Subject: Resolution No. R-967-19: Updated Report Analyzing Potential Impacts to Miami International Airport from Proposed Development on the International Links Melreese Country Club - Directive No. 220288

Subject: Proposed Miami Freedom Park Stadium - Revised Survey Elevation Analysis

RE: Determination Number DN-19-2947 Preliminary Land-Use/Airspace Analysis for the 131 Acre Site of the Proposed “Miami Freedom Park” project located at 1400 NW 37 Avenue, Miami, FL 33137 (Folio No. 01-3132-000-0080)

CONTROL SURVEY

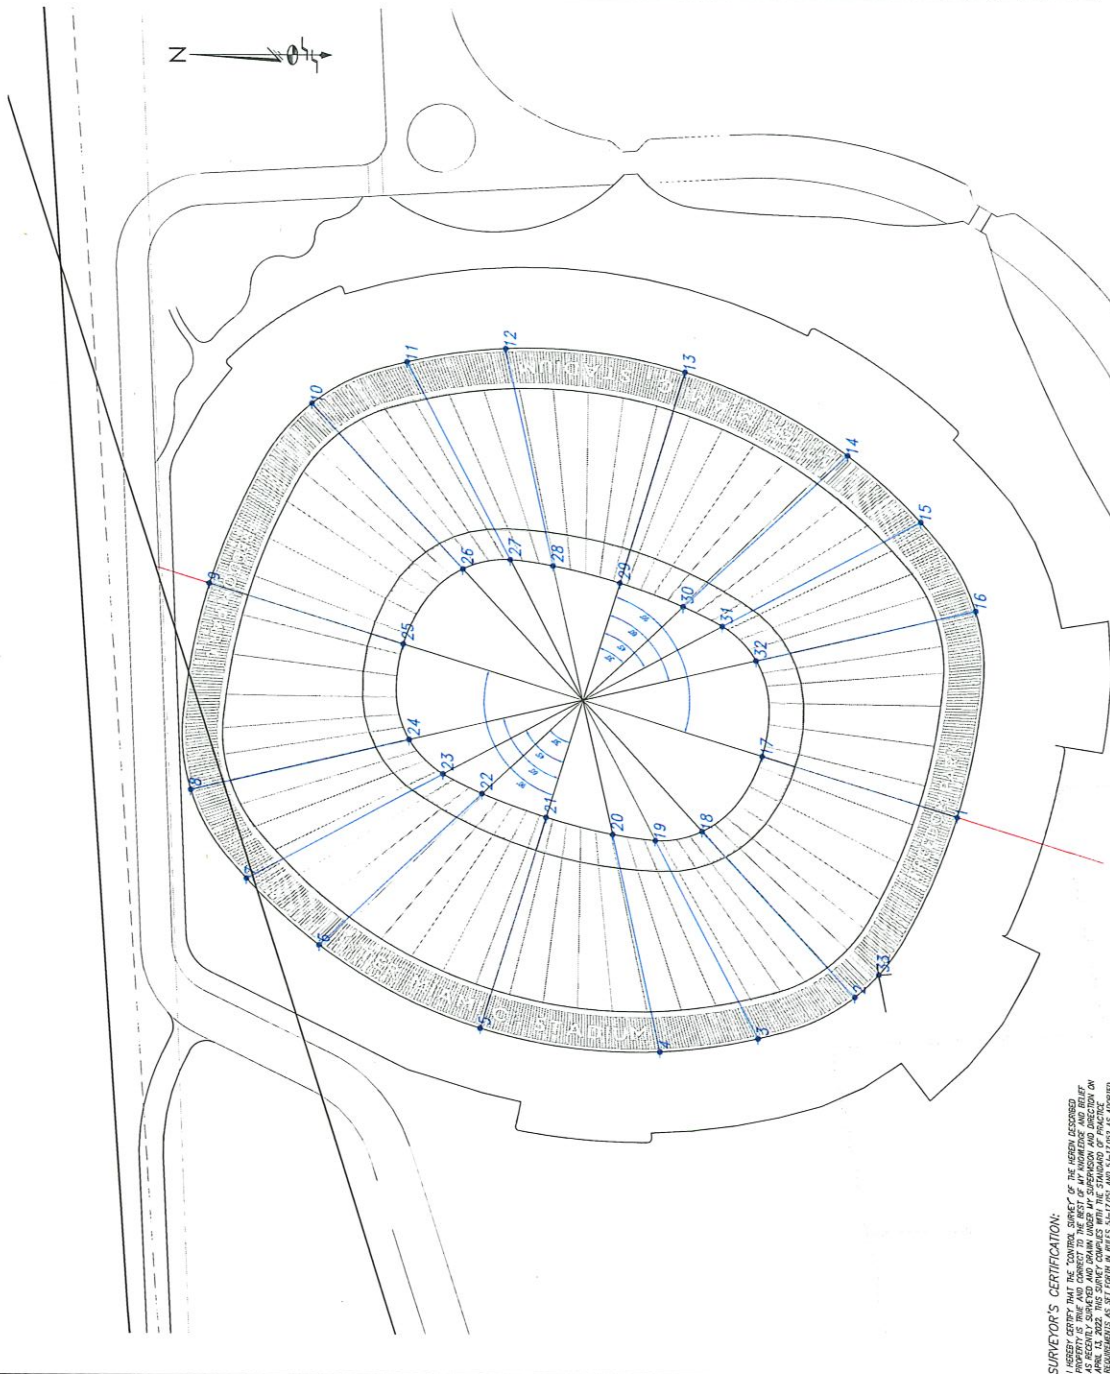
Please be advised that the revised survey dated April 13, 2022 from Schwebke-Shiskin & Associates includes thirty-three (33) points at specific GPS locations with elevations which range from 105 – 112 feet AMSL. The site elevation for each point was not provided. Since the maximum elevation for each point was expressed *in feet AMSL* on the survey, it is assumed that the site elevation was factored in and that the overall maximum elevation for the stadium will not exceed 112 feet AMSL. Therefore, the attached zoning analysis finds that the 33 points at the referenced locations and elevations conform to the requirements of Code of Miami-Dade County, Chapter 33, Article XXXVII Airport Zoning, Sec. 33-333 (B) Height/Airspace Regulations.
